Access Compliance Report
Public Rights-of-Way
(Curb Ramps)

Intersection ID: 27535	Main Street: COUNTRY_SQUIRE_CT	Cross Street: FAWN_HILL_RD	Location:	NE
ADA ID: 46CEA79126DA	Ramp Type: Perp	Initial Pass/Fail: Fail	Overall Compliance: No	Severity Score: 33.75

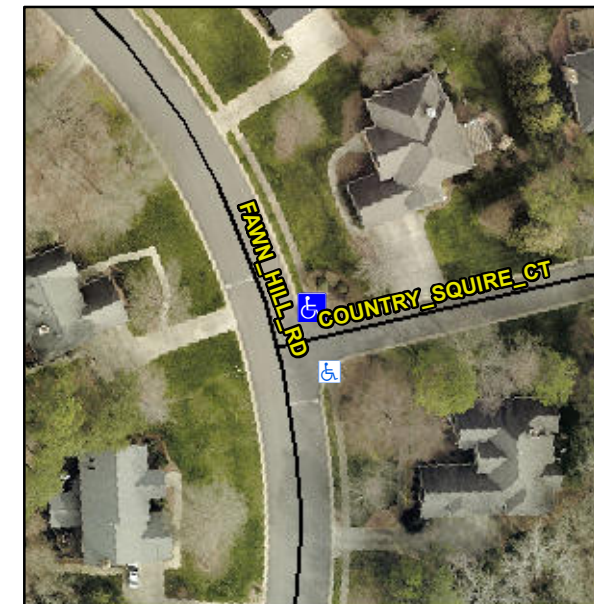
R304.5.1, R304.5.3

Compliance	Description	Data	Compliance	Description	Data
N/A	Ramp Length (in)	47.5	Yes	Ramp Slope (%)	6.2
No	Ramp Width (in)	44.0	No	Ramp XSlope (%)	7.3
N/A	Flare Type LT	N/A	N/A	Flare Type RT	N/A
N/A	Flare Slope LT (%)	N/A	N/A	Flare Slope RT (%)	N/A
N/A	Flare Traversable LT?	N/A	N/A	Flare Traversable RT?	N/A
N/A	Landing Length (in)	N/A	N/A	DWS Provided?	N/A
N/A	Landing Width (in)	N/A	N/A	DWS Contrast?	N/A
N/A	Landing Slope (%)	N/A	N/A	DWS Length (in)	N/A
N/A	Landing X Slope (%)	N/A	N/A	DWS Full Width?	N/A
N/A	Landing Curb? (Y/N)	N/A	N/A	DWS Offset (in)	N/A
N/A	Shared Landing?	N/A			
N/A	Gutter Ponding?	N/A	N/A	Gutter Slope (%)	N/A
N/A	Gutter Lip Ht (in)	N/A	N/A	Gutter X Slope (%)	N/A
N/A	Painted X Walk1?	No	N/A	Painted X Walk2?	N/A
	X Walk 1 Direction	To S		X Walk 2 Direction	N/A
N/A	X Walk 1 Width (in)	N/A	N/A	X Walk 2 Width (in)	N/A
	X Walk 1 Slope (%)	2.4		X Walk 2 Slope (%)	N/A
	X Walk 1 X Slope (%)	3.4		X Walk 2 X Slope (%)	N/A

Remove & Replace Entire Ramp.
